PLAN REVIEW COMMENTS FOR DP-05-23-018058

Plan Type:	Development Plan	Apply Date:	05/16/2023
Plan Status:	Active	Plan Address:	395E Parkside Commons BLUFFTON, SC 29910
Case Manager:	Dan Frazier	Plan PIN #:	R610 036 000 3712 0000
Plan Description:	A request by Conor Blaney of Ward Edwards Engineering on behalf of Lee Lucier of The Richardson Group L for approval of a preliminary development plan application. The applicant proposes to develop 4 commercial buildings, totaling approximately 16,000 SF, and supporting infrastructure. The properties are zoned New Riverside Planned Unit Development and consists of approximately 2.77 acres identified by tax map numbers R610 036 000 3710 0000 and R610 036 000 3712 0000 located along Parkside Commons within the New Riverside Village Master Plan. STATUS: Staff comments were reviewed at the June 21, 2023, meeting of the DRC. STATUS: The applicant re-submitted on June 29, 2023. STAFF: Staff comments for the re-submittal will be heard at the July 19, 2023, meeting of the DRC.

New Riverside Village Commercial
Town of Bluffton, South Carolina

Technical details: Vert. Datum: NAVD88, Horiz. Datum: SC83IF, Surveyed by: JWR, Surveyor's PLS: 28139, Project #: 220145, Date: 06/28/23, Designed by: ASH, Checked by: PRM. A scale bar shows 0 to 40 feet. The sheet number 'C401' is prominently displayed in a large box.

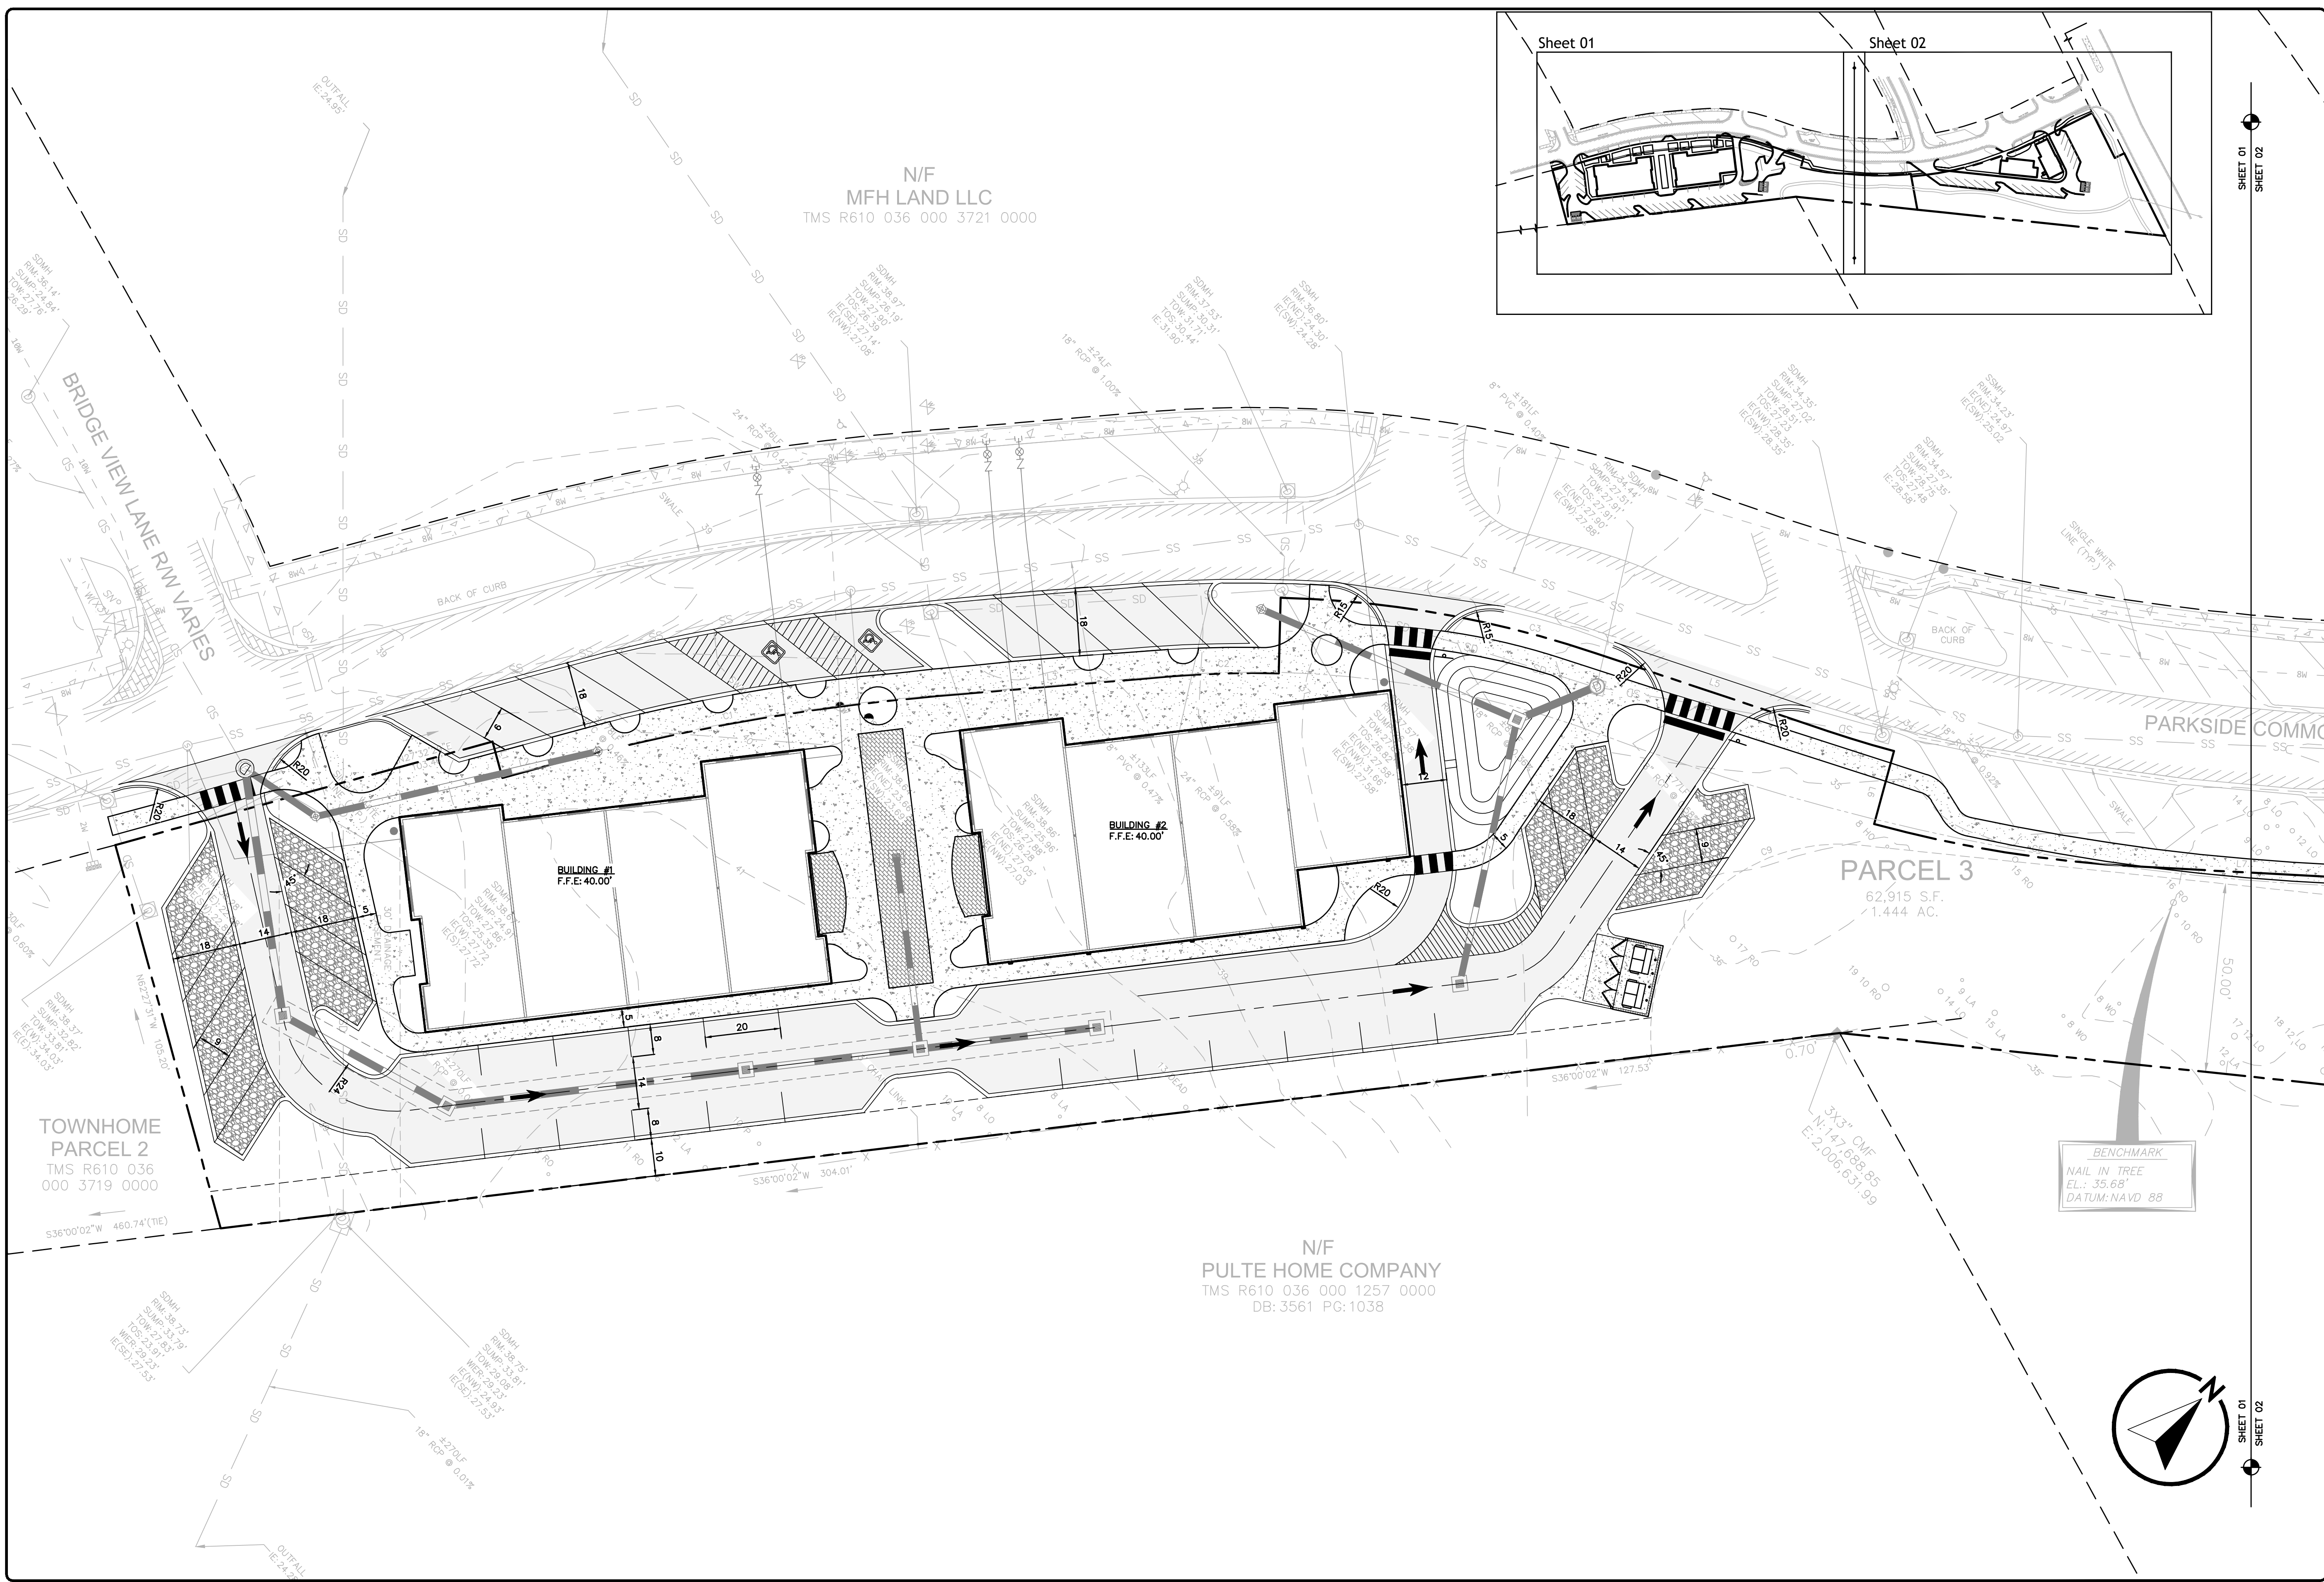
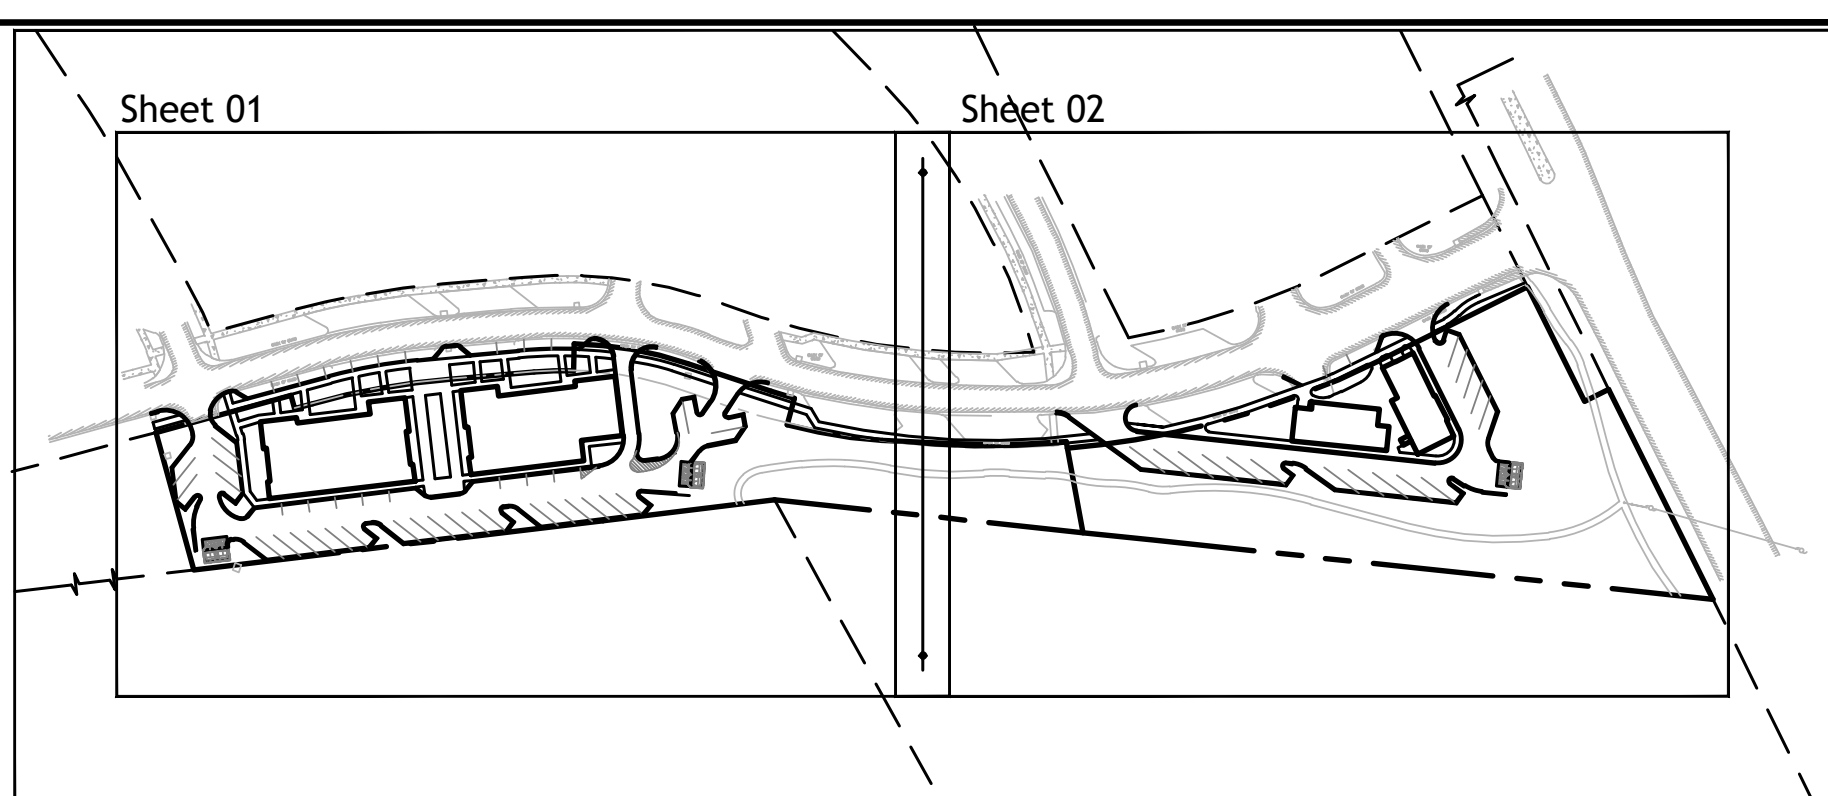
1. For the restaurant parcel, extend New Riverside Village Way roadway eastward to the property line within the existing 50-foot access and utility easement. Also provide a sidewalk on the south side of this roadway extension from the proposed sidewalk on Parkside Commons to the east property line.
2. For the restaurant parcel, move the intersection of New Riverside Village Way and the parking aisle further eastward, and realign the parking aisle as required, to provide for better overall road alignment.
3. Provide a 10' buffer along the south property line adjacent to the townhome parcel. Adjust the site plan as required.
